OFFICER DECISION REPORT - TRO OBJECTION REPORT

TITLE OF REPORT: Odd Down Bus Lane, Bath
PROPOSAL: Experimental Trial To Improve Traffic Flows on A367 Wellsway on Approach to the Odd Down Park & Ride
SCHEME REF No.: 17-030

Report Reference: **17-030**
Date: 29 August 2019

APPENDIX 2 Experimental Traffic Lane Layout, Drawing No. TC8314/ CONSTR/ 1210 rev.E

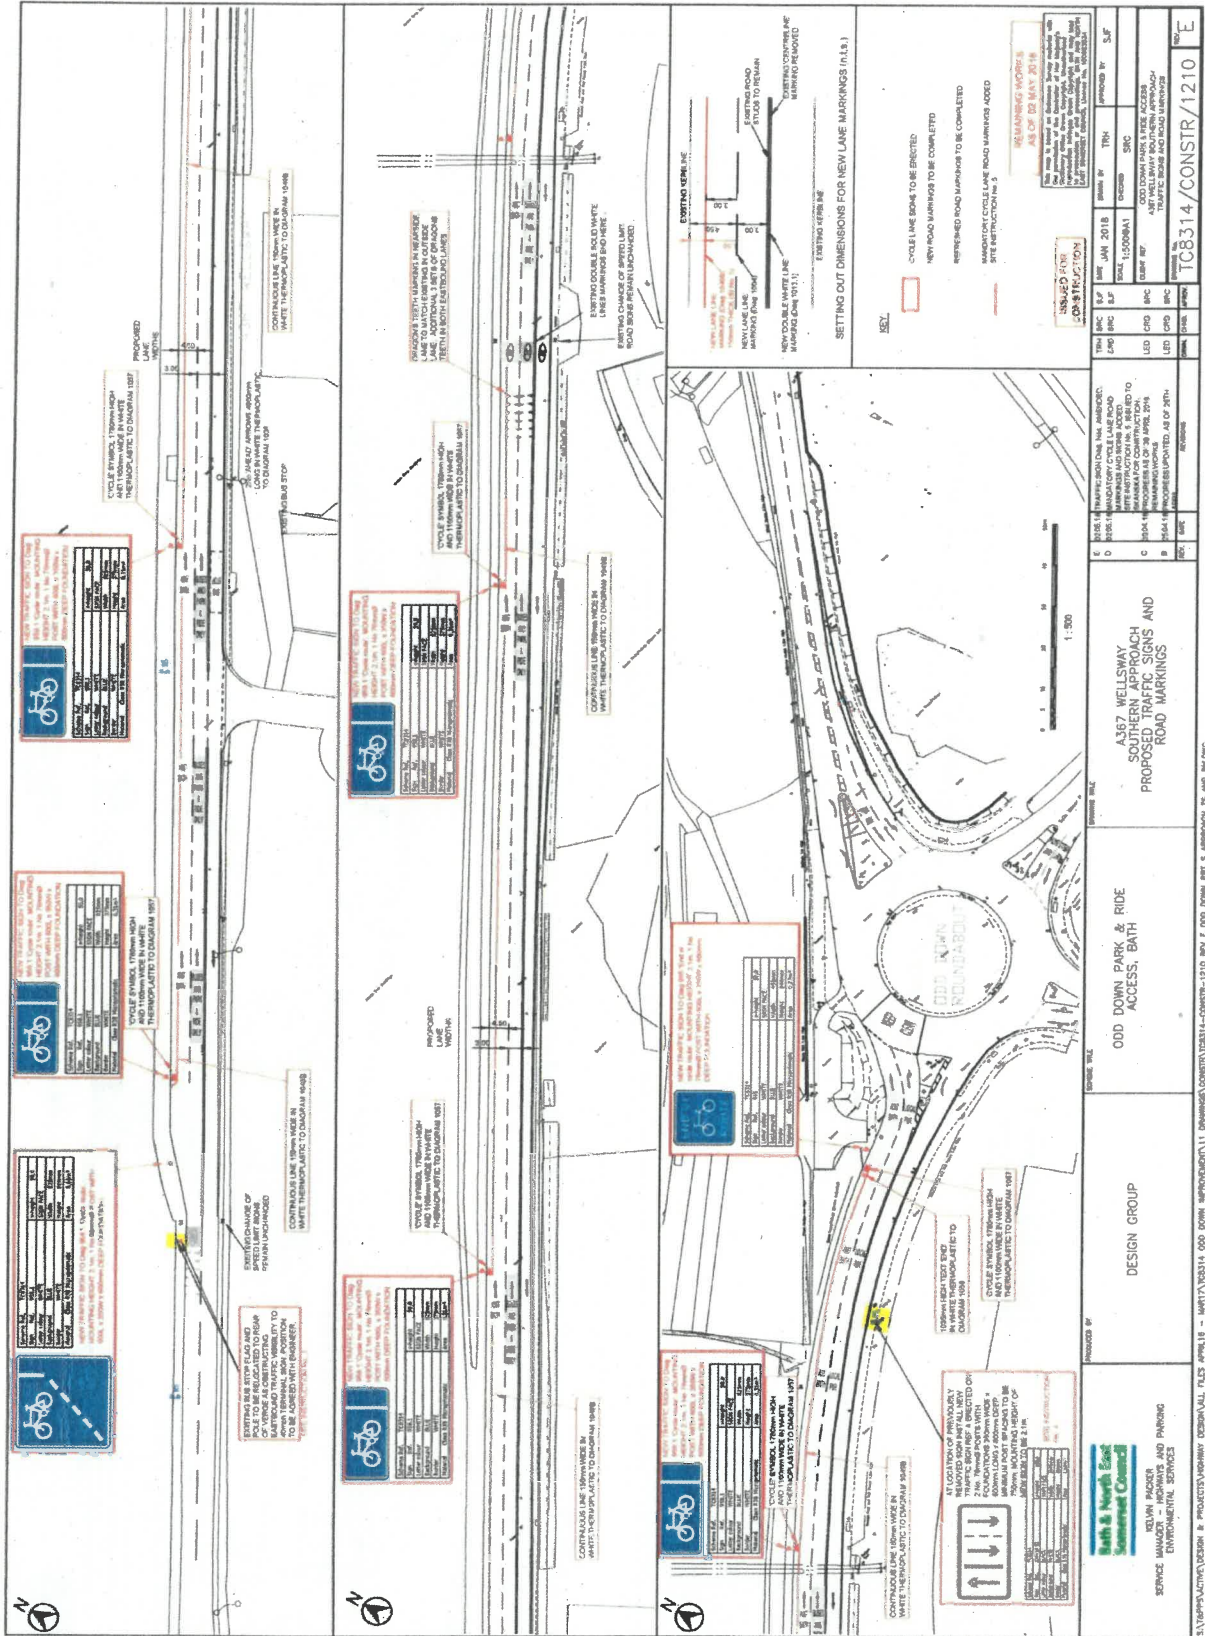
- a) Concern over lack of consideration for cyclists, as cycling is more hazardous with the bus lane removed due to the lack of segregation from the general flow of traffic (1, 3, 4, 6, 11, 20);

- b) As cyclists will use the "A367 Bath" lane, cars will then pass into the "P&R" lane. (3).

- c) Suggestion that a cycle lane be installed, preferably 2m to 2.25m wide rather than 1.5m wide, and that an advisory lane could be installed immediately (3).

a) No signage and road markings half completed causes both inbound lanes of traffic to attempt to head Bath-bound simultaneously (1, 5).

c) The road marking is farcical with some road markings going into the cycle lane. (17).

a) (i) Traffic uses the "P&R" lane to either go around the roundabout, cut back in to the "A367 Bath" lane close to the roundabout, or goes in and out of the Park & Ride site before heading towards Bath, hence having avoided queuing in the "A367 Bath" lane (1, 2, 7, 9, 12, 13, 14, 15, 16, 17, 18, 19, 20, 21, 22, 23, 24, 25, 26, 27, 29, 30, 31, 32, 33, 34, 35, 36, 37, 38, 39, 40, 41, 43, 44, 45).

- a) Traffic weaves dangerously between lanes. Suggests double white lines between the two newly designated lanes (8).

- b) Traffic using the “P&R” lane to go around the roundabout causes congestion on the roundabout and stops people getting to the Park & Ride. Suggests a “Keep Clear” box before the “P&R” entrance (15).

- c) In order to deter traffic from using the “P&R” lane and going around the roundabout, could the “Give Way” dotted line be placed on the roundabout (27).

- d) An overtaking restriction in the form of a solid white line has been added to the southbound route. Is this a mistake as the road is reasonably level, straight, and with a 40mph limit already in place (28).

- e) In order to prevent drivers from using the “P&R” lane and going around the roundabout, could the road markings be changed or barriers put up (31).

- f) The merging manoeuvre for local traffic merging to the right hand lane on the approach to the roundabout is dangerous, as the local traffic is moving from the slow left hand lane into the right hand lane where speeds are greater. Suggests making the "P&R lane a "P&R/ Local Traffic" lane (37).

Response: Bath-bound cyclists would have utilised the inbound "A367 Bath" lane which is 4.5 metres wide. This is the minimum carriageway width that is recommended to ensure that cyclists do not get "squeezed" by passing traffic, and this is why a formal cycle lane was not implemented at the opening of the scheme.

Response: The carriageway width of 4.5 metres should be adequate to ensure that vehicles do not pass into the "A367 Bath" lane when passing a cyclist.

Response: This comment was received prior to the cycle lane being implemented. A 1.5 metre wide cycle lane is the minimum recommended width for a cycle lane. It was not possible to provide a cycle lane of greater width as the 4.5m wide "A367 Bath" lane then gave only a minimum 3m width for Bath-bound vehicles.

Response: The road marking operations had been delayed due to a combination of availability of plant and inclement weather. Once the road markings and signage were completed, the lane discipline required from drivers was made apparent.

Response: As referred to in the response to 3.2.1 (a) above, the layout was originally designed so as not to incorporate a cycle lane as the nearside "A367 Bath" lane was deemed to be of adequate width at 4.5 metres wide for cyclists not to be "squeezed" by passing traffic.

The main "A367 Bath" traffic lane markings were therefore placed centrally within the 4.5 metre wide lane.

However, following complaints from cyclists the decision was made to provide the cycle lane. Unfortunately this has led to encroachment of the "A367 Bath"

traffic lane markings into the cycle lane.

Should the decision be made to retain the current experimental traffic lane layout, the roads markings would be rectified when the road is next resurfaced.

Response: Whilst the lane markings indicate the traffic lanes that drivers should be using, they are advisory and are not enforceable. It is acknowledged that drivers queueing in the correct "A367 Bath" traffic lane will be frustrated by those Bath-bound drivers using the "P&R" lane to avoid the queue.

The use of double white lines between the newly designated lanes is not recommended as it would be overly restrictive – drivers are not permitted to cross double white lines. For example, car drivers who decide that they would want to use the Park & Ride, having commenced using the “A367 Bath” lane, would not be able to cross into the “P&R” lane.

Response: A “Keep Clear” box in the vicinity of the Park & Ride entrance might further exacerbate the congestion on the roundabout and still prevent people from getting to the Park & Ride.

Response: Road markings at roundabouts are governed by national Department of Transport Highway Design Standards and “The Traffic Signs Regulations And General Directions 2016”, and these do not permit “Give Way” markings on roundabouts.

Response: A double white line has been placed between the northbound and southbound lanes so as to clearly define the two inbound (northbound) lanes towards Bath from the southbound lane.

Other comments received show that Bath-bound traffic does change lanes, and therefore the double white line also prevents southbound traffic from overtaking, and hence coming into conflict with northbound traffic.

Response: One of the objectives of this trial was to provide an incentive for drivers to use the Park & Ride site by giving them priority with buses in the “P&R” lane. However with this arrangement the traffic lanes can only be advisory and are not enforceable.

In order to prevent traffic from incorrectly using the “P&R” lane, the priority for

Park & Ride traffic would need to be withdrawn which does not meet with the trial objectives. Also barriers cannot be placed on the highway.

Response: The merge point is within the 30mph section of the road and traffic is slowing as it approaches the roundabout. Also, the accident record shows no record of any accidents along the two lane length of the A367 (in either direction) or on the Odd Down Park & Ride roundabout since the trial commenced (latest accident record up to 30th June 2019).

Enabling local traffic to use the right hand lane reduces its impact as a lane set aside for those using public transport.
